Access Compliance Report

Public Rights-of-Way

Intersection ID: 28446	Main Street: SHINING_OAK_LN	Cross Street: SUMMER_CREEK_LN	Location: SE
ADA ID: 102A0AB890CB	Ramp Type: BlendTrans1	Initial Pass/Fail: Pass	Overall Compliance: No
		Severity Score: 5

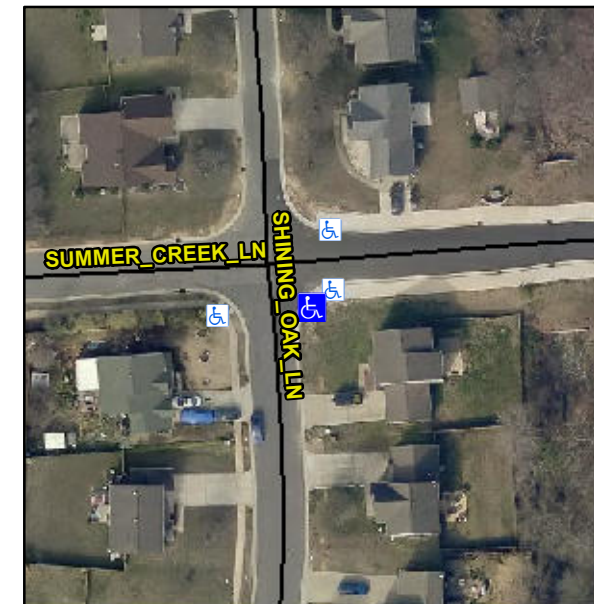
Not Found, R304.2.1, R304.5.4

N/A	Ramp inside XWalk1?	N/A	N/A	Ramp inside XWalk2?	N/A
	Road Slope (%)	0.4		Clear Space?	Yes
	Road X Slope (%)	4.3	N/A	Clear Space to XWalk (in)	N/A
Yes	Any Obstructions?	No	Yes	Storm Grate/Utility Hazard?	No
	Obstruction Type			Storm Grate/Utility Type	
		N/A			N/A
			Yes	Surface Condition? (G/P)	Good
			No	Curb Slope (%)	19.6

Remove & Replace Curb Ramp With Two New Directional Ramps or Equivalent. Remove & Replace Gutter.
